City of Biddeford
Historic Preservation Commission

HISTORIC PRESERVATION COMMISSION REPORT

RE: **Item 3.a: 2026.14 HPC Review for Coastal Oaks, LLC to remodel the building at 12 Pearl Street, Tax Map 40 Lot 72, in the MSRD-1 Zone.**

East Elevation, July 22, 2026

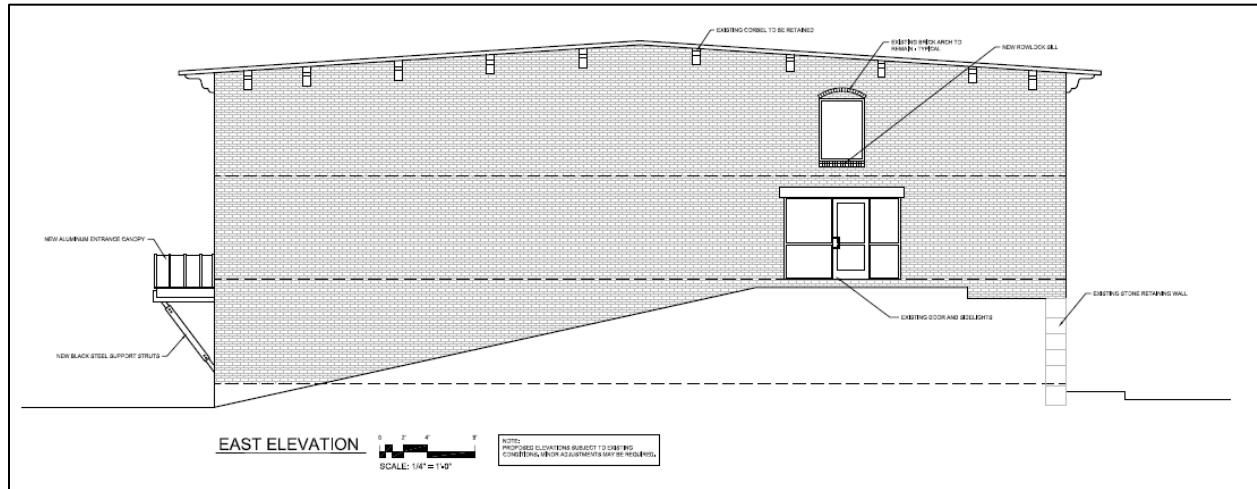
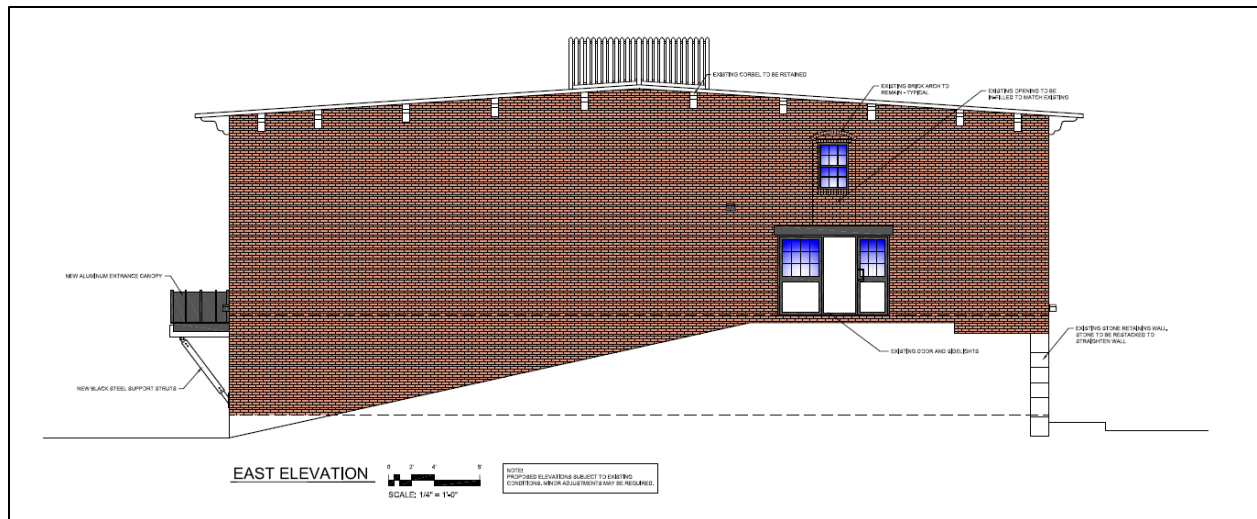
Existing door to remain. Existing window above door is partially infilled to accept double hung window. Wall pack fixture provides light.

South Elevation, August 12, 2026

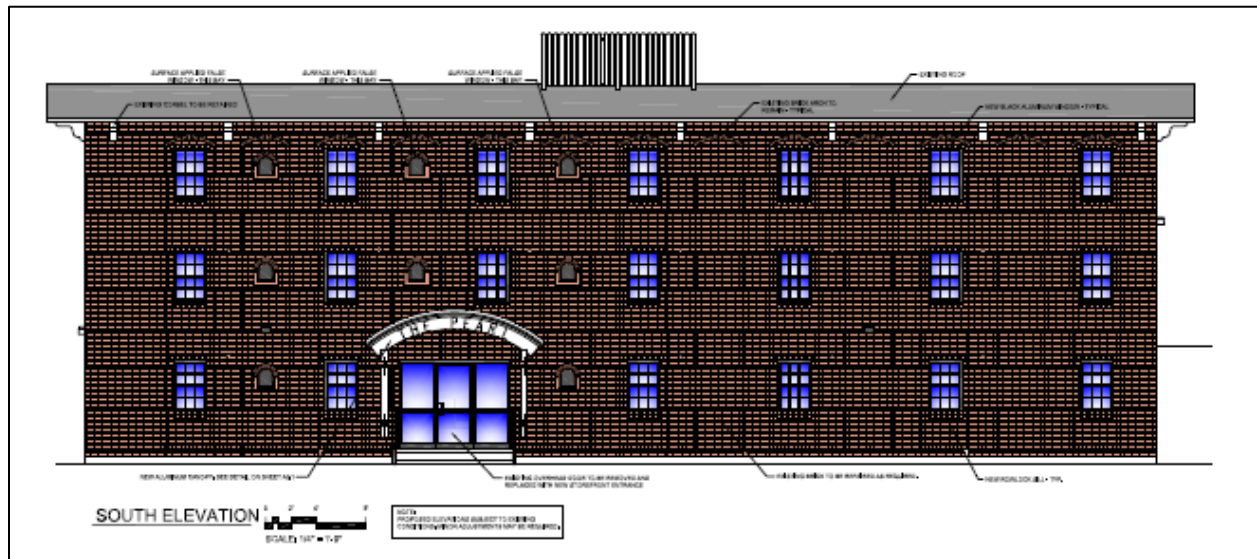
The latest version of this elevation shows double hung windows in place of previously depicted casement windows, eight applied porthole windows, and screening at rooftop HVAC. Lighting is provided by two wall pack fixtures.

This proposal disturbs the regular rhythm of existing bays.

Canopy Detail. South Elevation

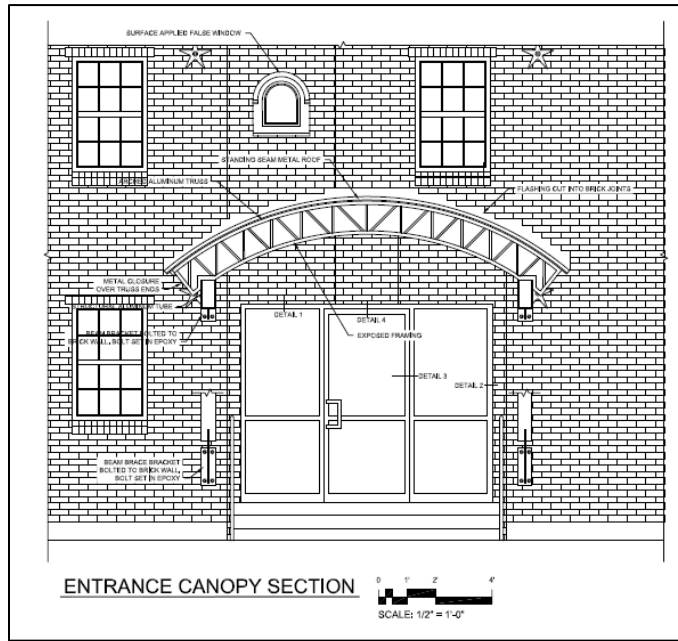
Detail shows applied false porthole window above canopy. Canopy is arched aluminum truss with standing seam metal roof.

West Elevation, August 12, 2026

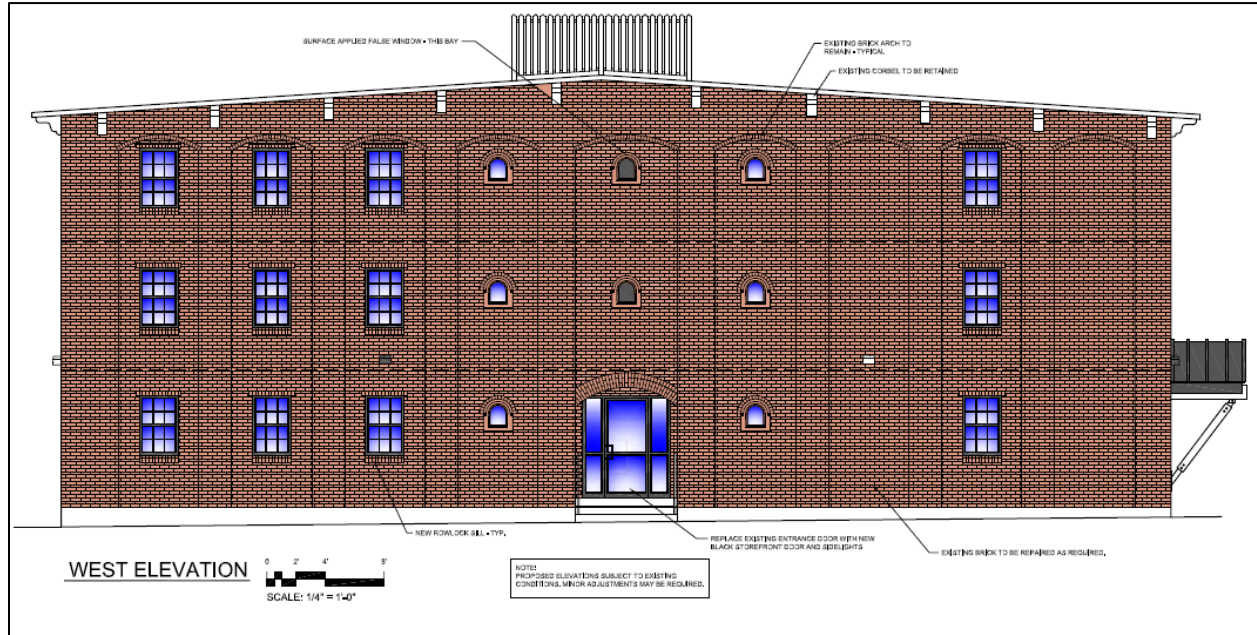
Latest elevation shows both existing porthole windows to remain and applied false porthole windows. New openings with double hung windows alters the rhythm of the façade.

A1.1

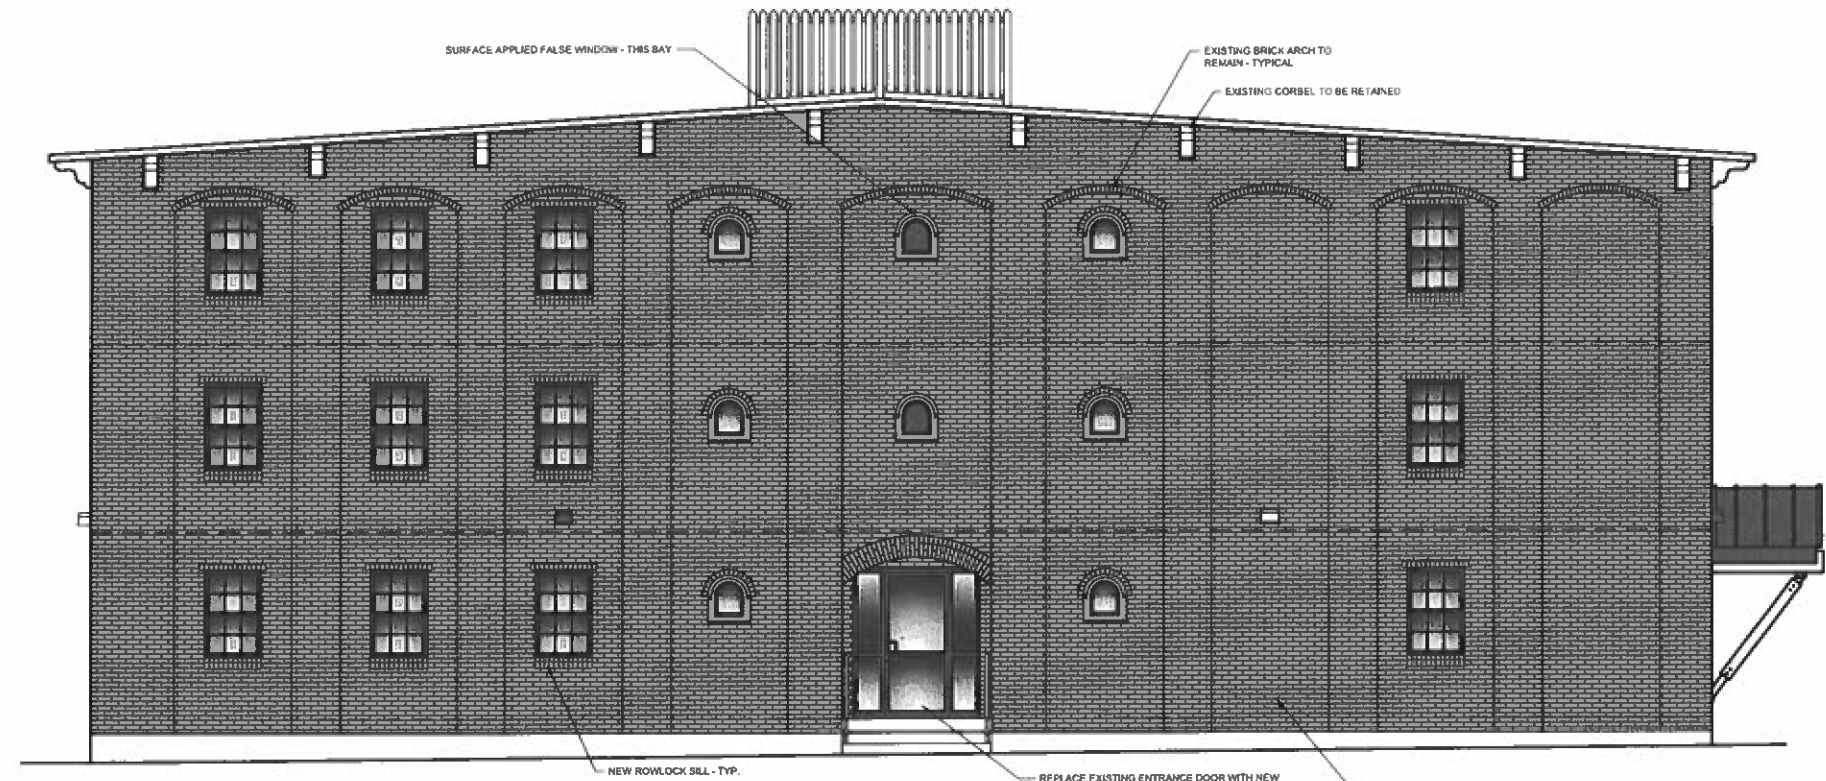
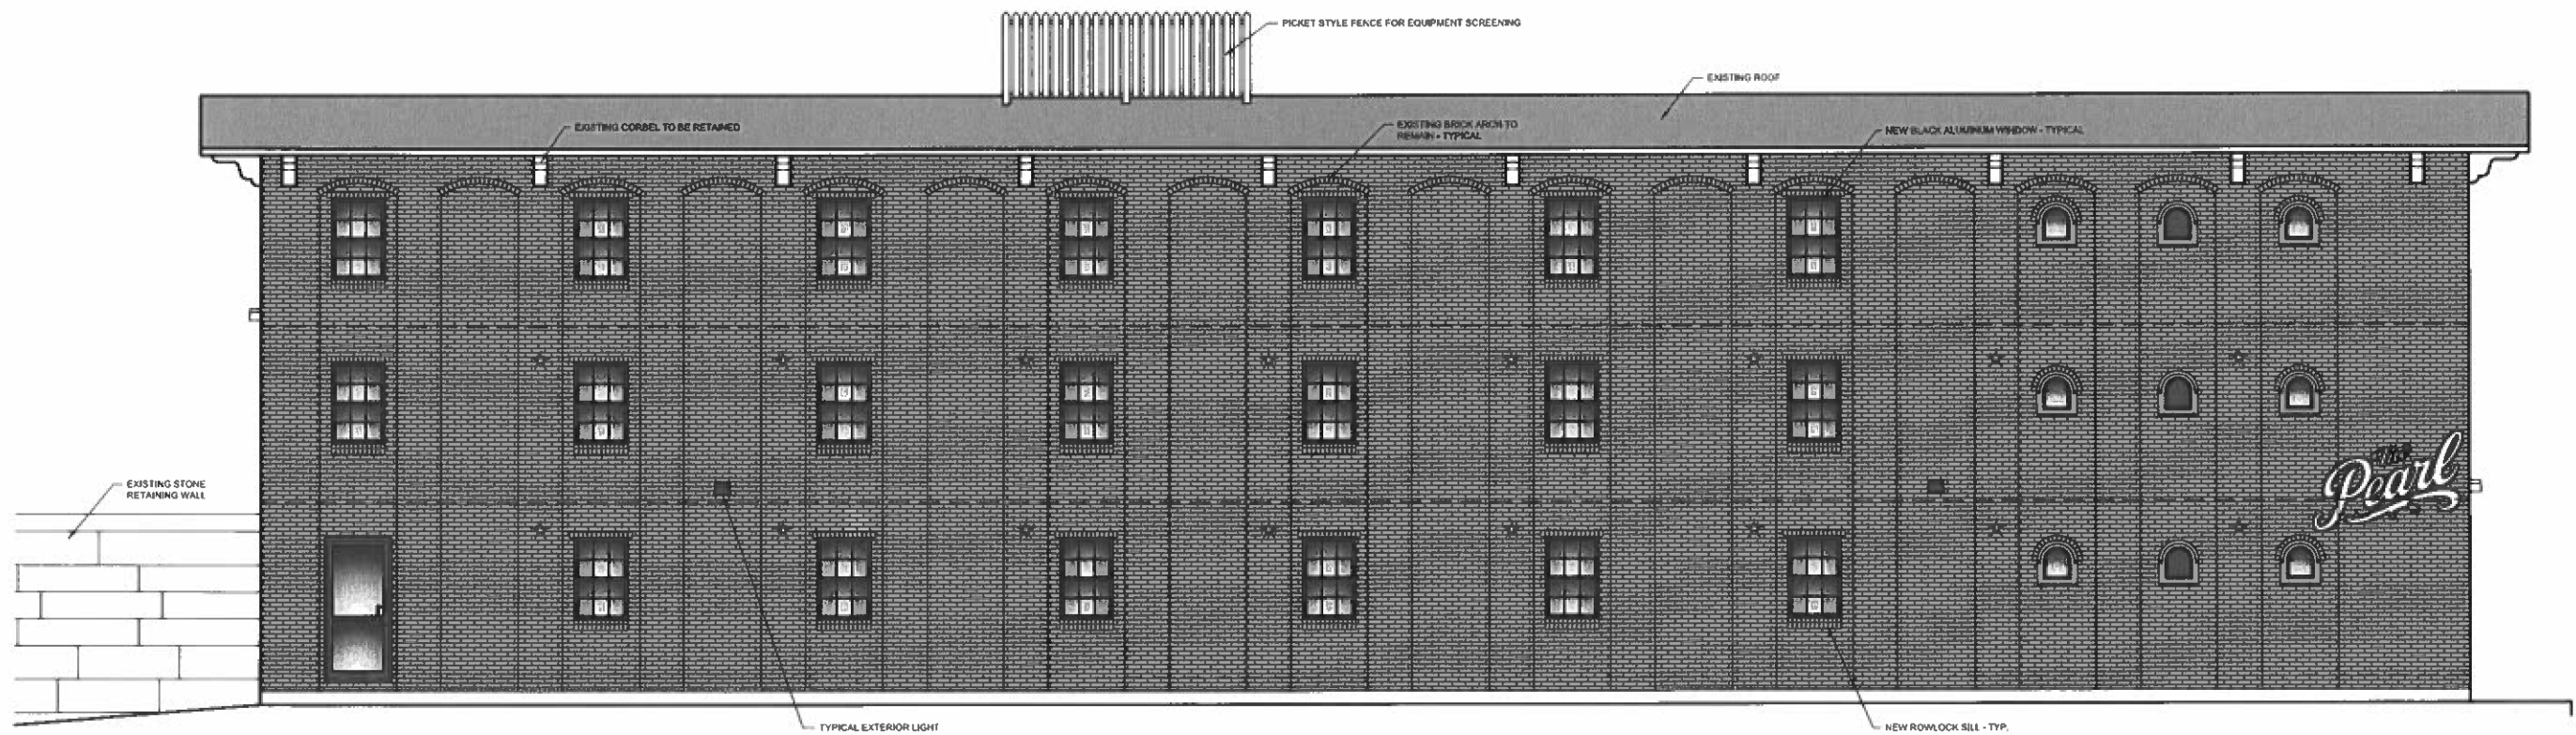
- **All windows will be set in, architectural submitted were erroneous.**
- **Larry asked why the windows on the North elevation are bigger than the others**

- **Larry spoke of her concerns that the applicant’s changes are changing the fundamental character of the structure and losing the rhythm of the windows in spots. A stronger preservation solution would be to have a regular pattern of windows.**
